8496A-02

Modification Recommended Service Note

8496A – Manual Step Attenuator

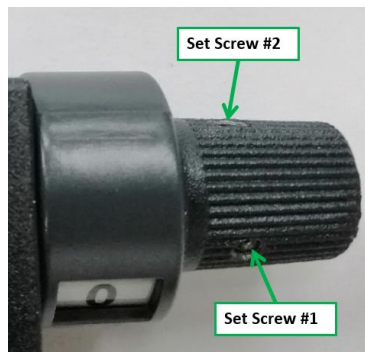
The attenuation knob was not securely tightened to the internal shaft, causing it to turn further. This is due to an insufficient torque that was applied to tighten the set screw during assembly at the factory.

This issue can be fixed by re-tightening the screws on the rotating knob.

- (1) Rotate the knob clockwise until it reaches the last attenuation step, which is at 0 dB.
- (2) Loosen the 2 set screws (0.05" Hex screw bit) on the knob slightly until the knob can freely move, and then align the knob so that the indicator label number "0" is located at center on dial cover window.

- (3) Tighten both set screws with a 0.05" Hex screw bit and 4.0in-lbs torque driver.

(4) After tightening both set screws, rotate knob counter-clockwise until it reaches the maximum attenuation (11/70/110dB). To ensure the attenuator functions properly, rotate the knob clockwise back to minimum attenuation (0dB), and repeat the movement for 10 cycles.
